**RE: Response to Comments  
Modification Request No. 13 – Mine Site Water Management  
Mary River Project, Type 'A' Water Licence - 2AM-MRY1325 - Amend. No. 1**

**Baffinland Responses to Comments**

## MEMORANDUM

P/A NO. NB102-181/71	REF NO. NB21-00726
<b>FIGURE 2</b>	
REV 0

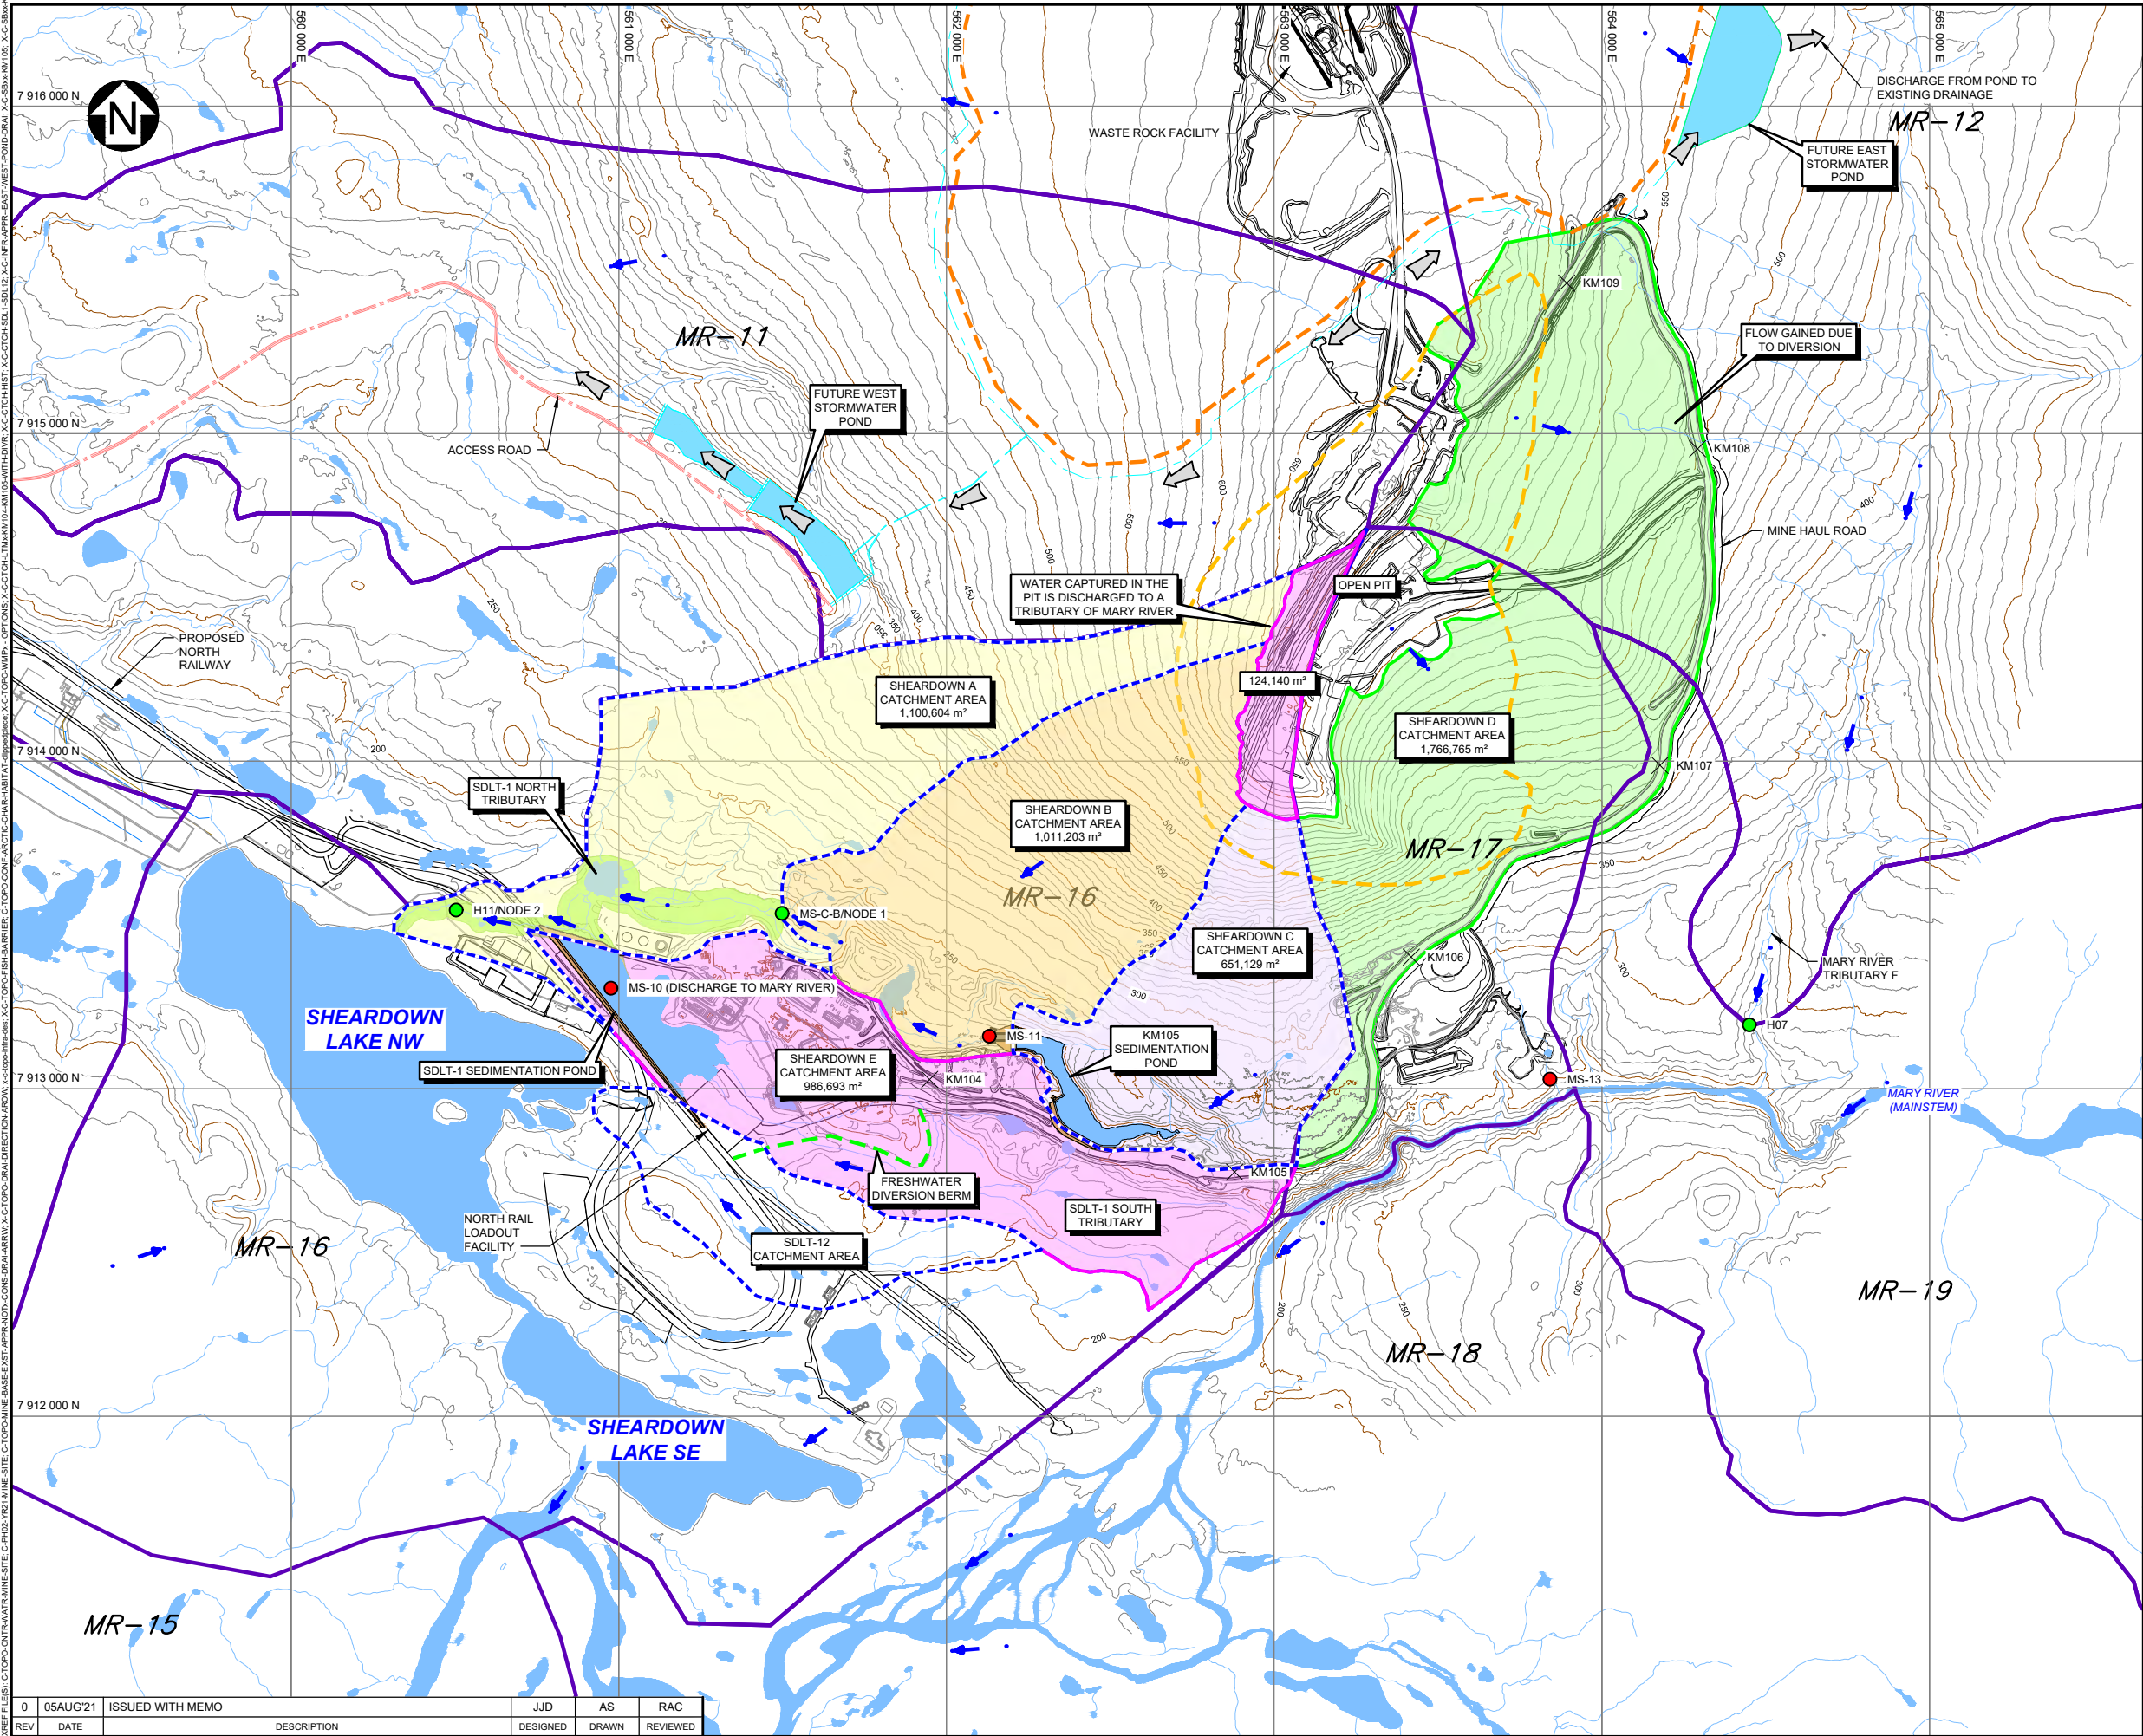
CIRNAC-2	<p><b>Diversion Berms</b></p> <p>Diversion berms are proposed in the Mine Site Water Management Plan for both areas 1 (Mary River) and 2 (Sheardown Lake and tributaries). As drawn on the plans, it appears the berms divert water but also collect water. This was not discussed in the text and requires clarification.</p> <p>Specifically, on Figure 4.2 Plan – Option C has a berm with a shallow angle, which would cause water to accumulate behind it, and on Figure 5.1 the diversion berm crosses a valley and stream, which would also cause water to pond.</p>	<p>(R-02) CIRNAC recommends the licensee confirm if the proposed diversion berms will collect water and clarify how it will be managed.</p>	<p>The diversion berms shown on Figures 4.2 and 5.1 are conceptual only and require design. The intent is to maintain positive drainage so that the berms do not collect water.</p>
CIRNAC-3	<p><b>Sediment traps</b></p> <p>One of the proposed types of infrastructure in the Mine Site Water Management Plan are sediment traps. Section 3.4.3 specifies "Traps may be formed through excavation, above ground embankments, or a combination of the two". Excavations in permafrost areas can lead to permafrost disturbance, particularly if water ponds in the excavation. The plan does not include any details on approximate dimensions of sediment traps or what measures would be taken to protect permafrost in the ground below the traps.</p>	<p>(R-03) CIRNAC recommends the licensee provide more details on the sediment traps including what measures would be taken to prevent permafrost degradation below the traps.</p>	<p>Measures to prevent permafrost degradation will need to be incorporated into the design of sediment traps (lined, emptied and don't hold water). In most cases, sediment traps will be constructed above ground and in existing low areas. Where the ground surface is already highly disturbed, sediment traps may be excavated.</p>

The flow path of water discharged from the KM105 Pond to the SDLT-1 north tributary is shown on Figure 2. Water discharged from the north embankment flows overland and subsurface through a vegetated boulder field to a natural pond north of KM104, where a potential “KM104 Pond” has been under consideration (Photo 1). The outflow of this pond is through a narrow rock-filled valley (Photo 2). Flow is subsurface through the valley, and then daylight downstream as shown on Photo 3. A fish barrier exists at the location shown on Photo 3 under nearly all flow conditions; North/South Consultants Inc. (NSC) identified two fish reaching the small pond in the foreground of Photo 3 on one occasion during high water conditions (Michael Johnson, pers. comm.). Baseline habitat information for four reaches of SDLT-1 extracted from Appendix 4.1-1 of NSC (2012) (presented in Appendix 7C of the Final Environmental Impact Statement; Baffinland, 2012) is included in Appendix B of this memo.

Pond discharges are predicted to double the average daily flow rate at Node 1 under all three scenarios. At Node 2, the influence of the pond is muted considerably because Sheardown A Catchment is added to streamflow and Sheardown E Catchment is removed (Figure 2).
